From: dwcartwright@transystems.com
Subject: RE: Lake Park Arch Bridge Report Review
Date: October 4, 2018 at 3:55 PM
To: ckreilly@outlook.com
Cc: Wesley.Weir@wsp.com

Lake Park Arch Bridge
Load Calculations.pdf

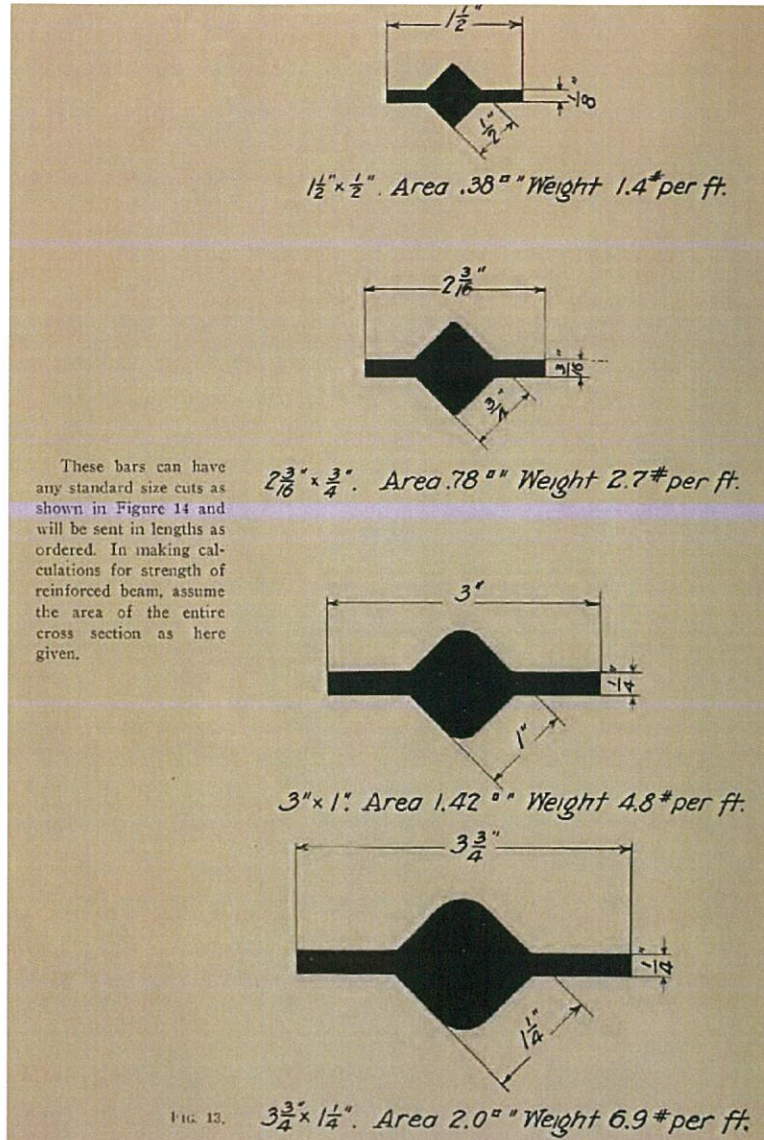
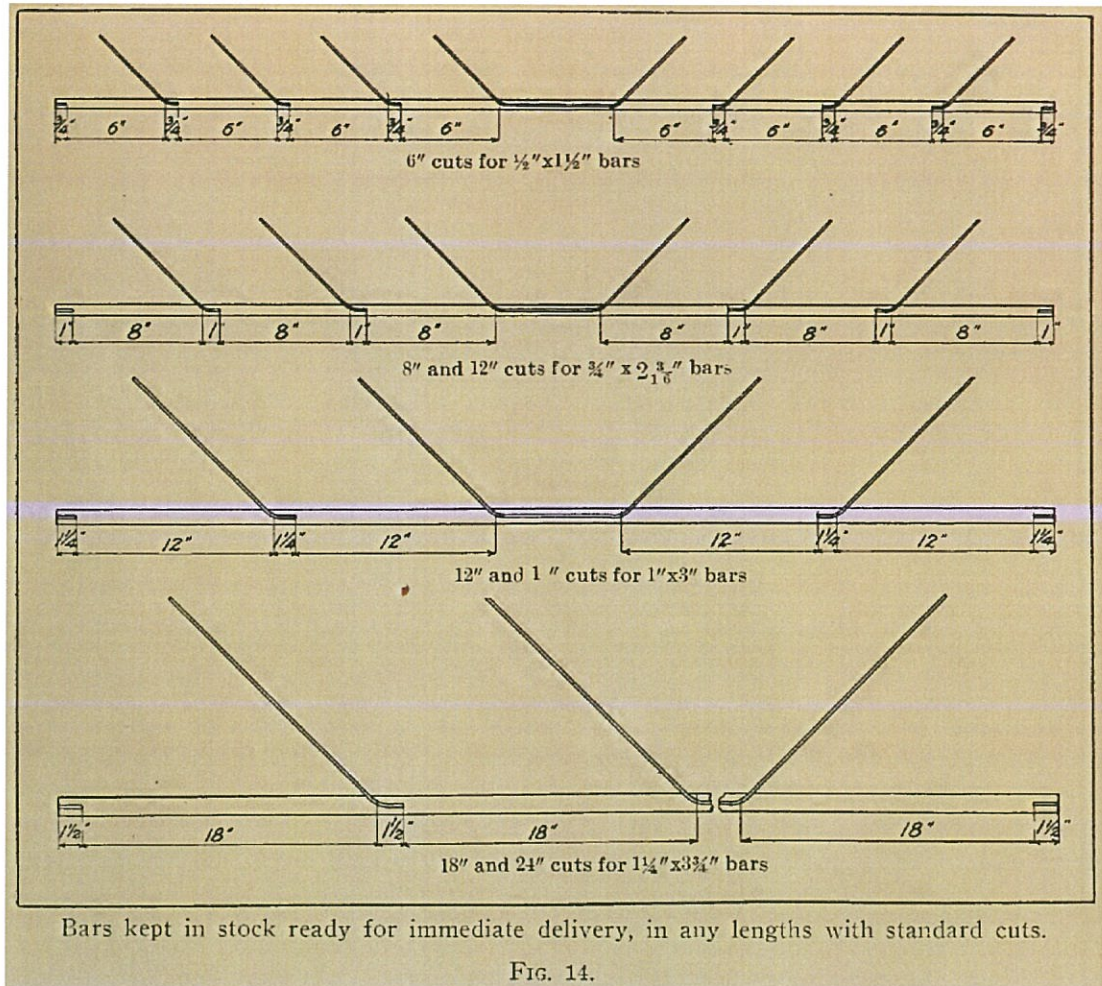
square bar at predefined lengths. These cuts allow the fins to be bent up to provide shear reinforcement for the concrete element. The images below from Kahn's 1904 Handbook illustrate this configuration.

- The 1904 Kahn bar literature suggests the full bar areas (square bar area plus bar fins) can be used to determine the strengths of reinforced beams. However, we do not believe this is an appropriate approach for two reasons. First, the bent up fins provide no bending strength. Second, even when bars are not bent up, the discontinuity of the steel where fins are transversely slit makes use of the fins questionable. From the 1904 Kahn bar literature Figure 14 and deck underside photograph earlier, only the middle 6" of the bar length has continuous uncut fin steel, and only this length should be considered effective as having the full square bar plus fin area. Regions beyond the middle 6" should consider the square bar area only.

The review of our report states that the Khan bars have transverse slits even where bars are not bent up, and we do not believe this to be true. The Khan bars are fabricated as one continuous bar with a diamond-shaped inner core and fins on the outside. In order to create the include shear reinforcing, the fins are cut with a small transverse slit and variable-length longitudinal cuts which then allow the bars to be bent up. The bars are not fabricated with these cuts pre-made, and the center portion of the bar is left continuous to allow for full capacity of the bars (core + fin) in flexure. This is shown in Fig 11 on Page 4 of GRAEF's review.

Furthermore, GRAEF states that only the middle 6" of the bar length is left continuous and uncut. We believe GRAEF has incorrectly interpreted the standard cut diagram (Fig 14 on Page 6 of their report). In this diagram, the center portion of the bars shown is intentionally **not** dimensioned, as this length would be customized based on the configuration of the member being reinforced. The purpose of this diagram is strictly to demonstrate the dimensions for these cuts for different bar sizes and lengths of bent shear bars. This diagram does not specify the uncut flexural length left in the middle of the bar, and the only reason it is drawn so short is likely just to fit all the detail needed on the page. In fact, the bottom diagram showing 18" and 24" cuts specifically has a break line shown in the middle of the bar.

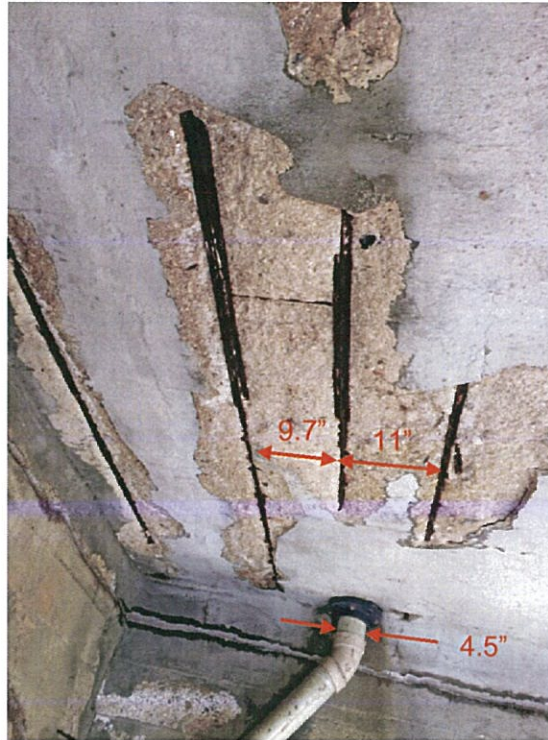
- Original design drawing deck cross sections and field observations of underside spalls (see image above) suggest the Kahn bar fins are bent up for most of the deck width. This will reduce the reinforcement areas assumed by both GRAEF and TranSystem.
